Office Action Summary

10/826,014

MIYATA, YASUHIITO

DETAILED ACTION

FIG. 3

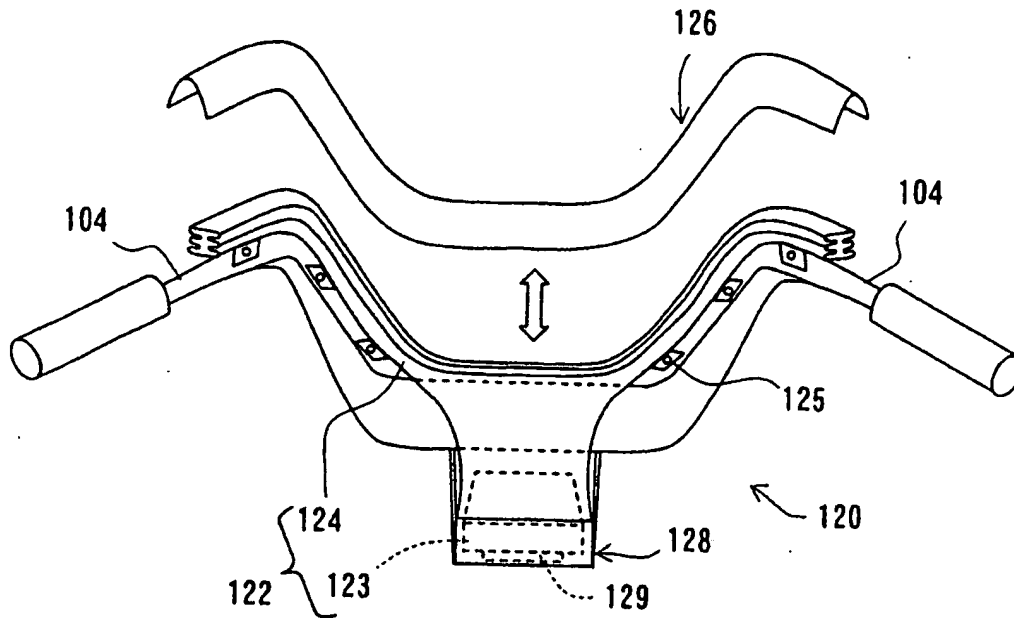
a. In Figure 3 and paragraphs [0018] and [0027], "A-A" should be "4-4", as a section line should be named for the figure it represents.
